Anna Lalor
13 The Waxworks
Rathborne Village
Ashtown
Dublin 15
D15 YX92

An Bord Pleanála
64 Marlborough Street
Dublin 1
D01 V902

27 October 2022

Subject: DART+ West Railway Order Application

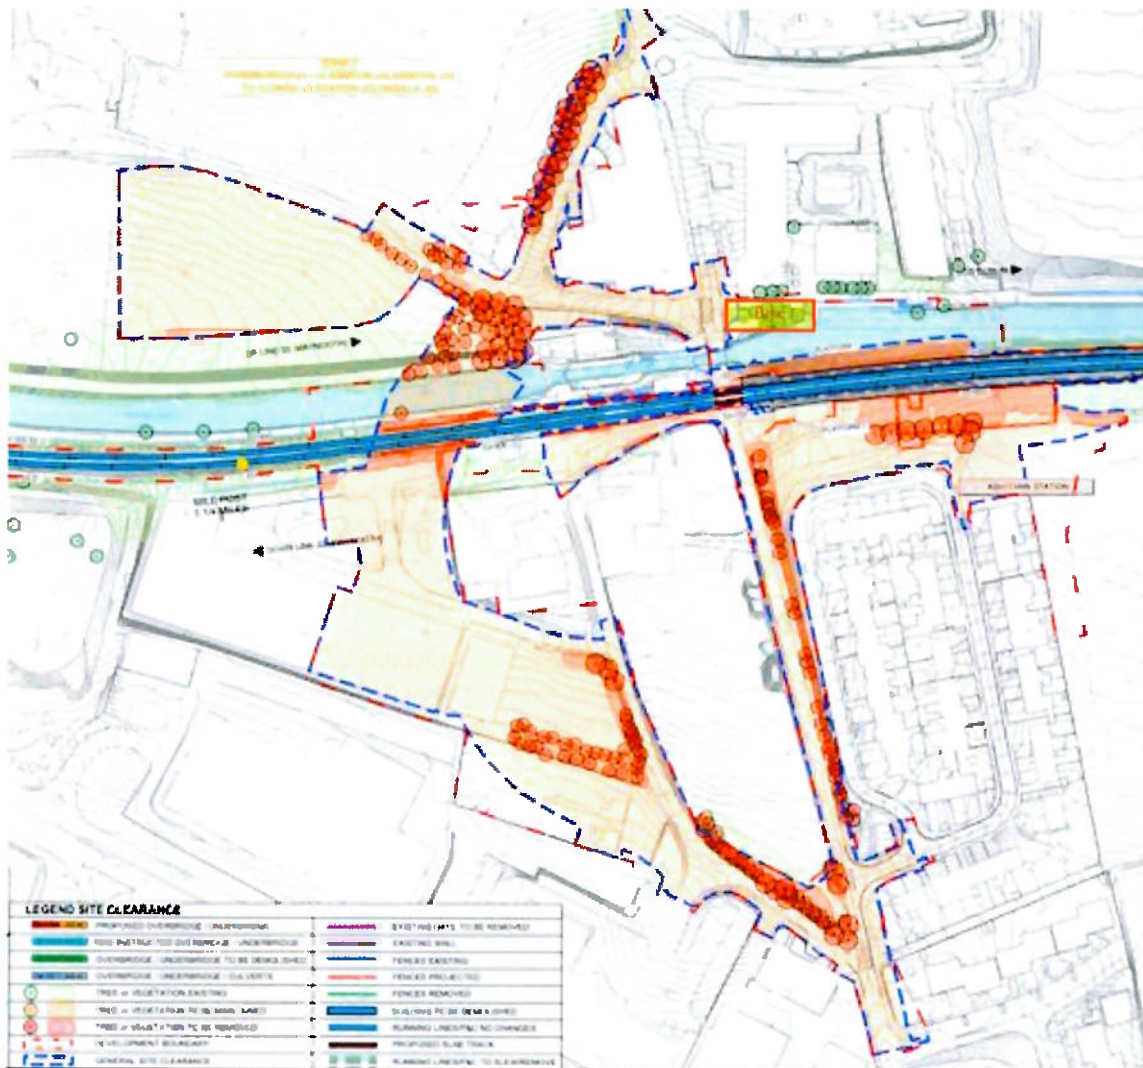
amount of trees, hedgerows and other vegetation. The original clearance map below does also not make clear that at least some vegetation and possibly some trees (highlighted in yellow as an addition to the map) will be removed to facilitate bicycle parking.

I propose that any approval of the railway order application is subject to the condition that Irish Rail (1) conduct an Arboricultural Impact Assessment and share it with An Bord Pleanála and the public prior to approval to proceed with DART+ West works; and (2) evaluate how the level of tree and vegetation loss can be minimised from the DART+ West project compared to current proposals. ¹⁴

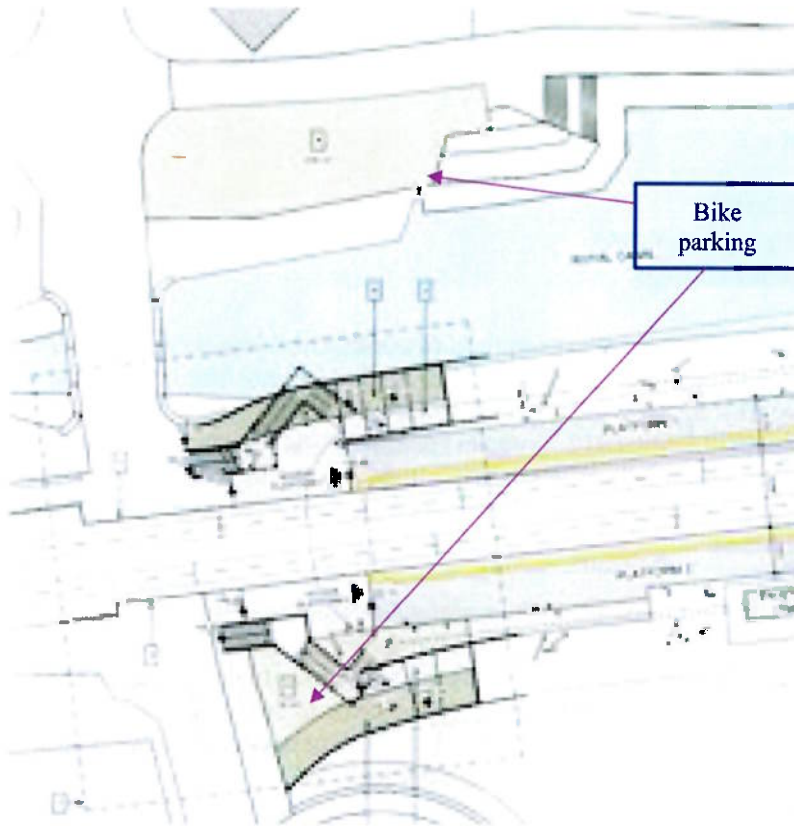
While tree removal is not shown in the diagram MAY MDC LMA SC05 DR Y 0001 D at the location of bicycle parking¹⁵ the description of the proposed development makes it clear that existing vegetation will be removed¹⁶, while a response from Irish Rail in relation to queries indicates that “the existing trees will be preserved as much as possible” (see annex 4).

The analysis in table 4-17 indicates that 37 bicycle parking spaces are needed requiring 61m² of space. However, 230m² is being allocated to the north of the canal (area mentioned above) with a further 70m² at the south of the railway. It is not clear why the areas each side of the canal are so unevenly distributed, or why such a large area is needed relative to Irish Rail’s own analysis.

Greater dispersion of bicycle parking could minimise the impact on vegetation and trees north of the canal.

I propose that any approval of the railway order application is subject to the condition that Irish Rail (1) re-assess the distribution of bicycle parking north and south of the canal and railway at Ashtown, making changes as relevant; (2) re-assess the area being taken for bicycle parking at Ashtown compared to the area determined by its own assessment¹⁸; and (3) minimise the extent of removal of vegetation and oak trees located in the proposed bicycle parking location north of the canal.
